Project title	Victoria North River and Flood Alleviation Works	Job number	281943
cc		File reference	4-05-02
Prepared by	Louise O'Regan / Emma Cecil / Rob Parry	Date	2 March 2022
Subject	Hydraulic Assessment of HIF Infrastructure Proposals – Rev 2

Technical Note

Table 6 - Summary of HIF Infrastructure Works modelled

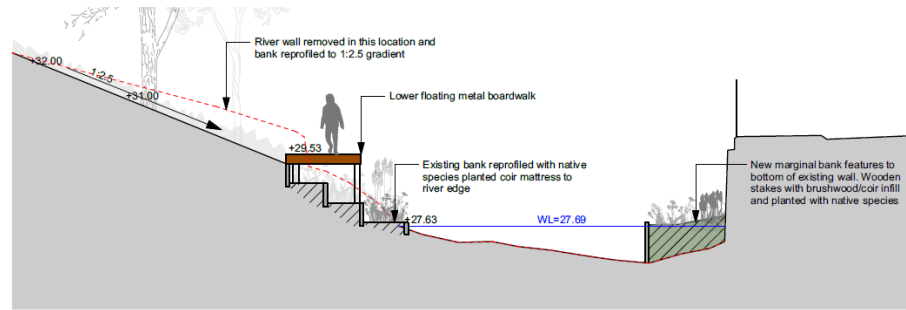
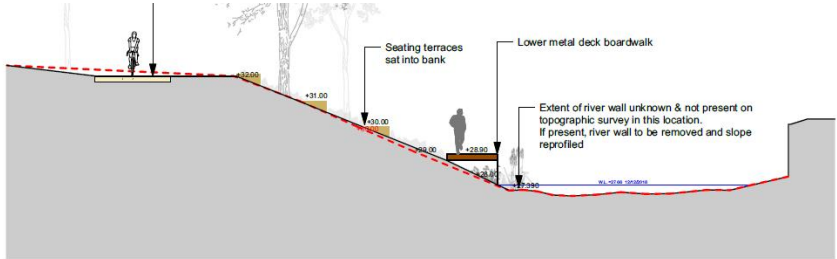
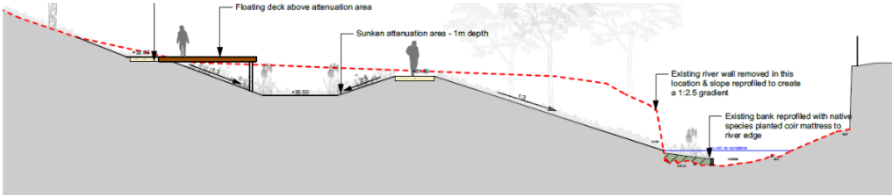
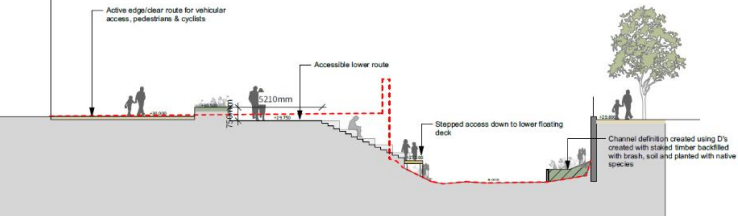
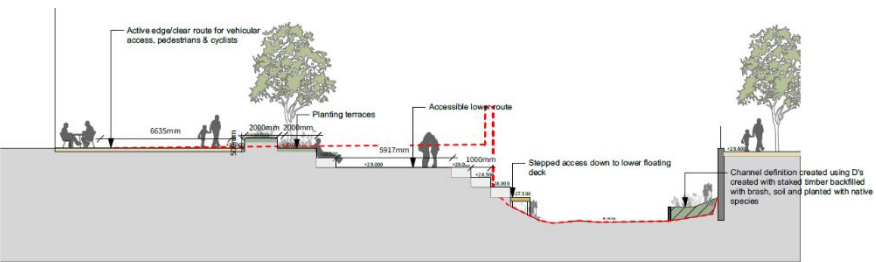
EA Model Review Comments	EA Model Review Actions	Addressed in the HIF Infrastructure Assessment model?
	Additionally, the drawings were compared to amended cross sections with the following issues noted: A-A (IRK01_1449): All OK aside. 2d elevations appear to tie in with design on right bank and are lower than baseline. B-B (IRK01_1293): High roughness used on LB in the model but nothing is indicated there on the drawing - please clarify. C-C (XS_C-C): All OK D-D (IRK01_1042 and IRK_1.05): Expected to see the first step on the right bank at 27.5m (28m in the model) although the arrow in the design drawing does obscure the value - please clarify. Wall successfully removed and 1d-2d boundary elevations have been altered to reflect the change. E-E: Hard to tell what cross section this is reflected in - is it IRK_1.05 i.e. same as D-D? F-F (XS_F-F): Amendments look OK and RB wall removed successfully.
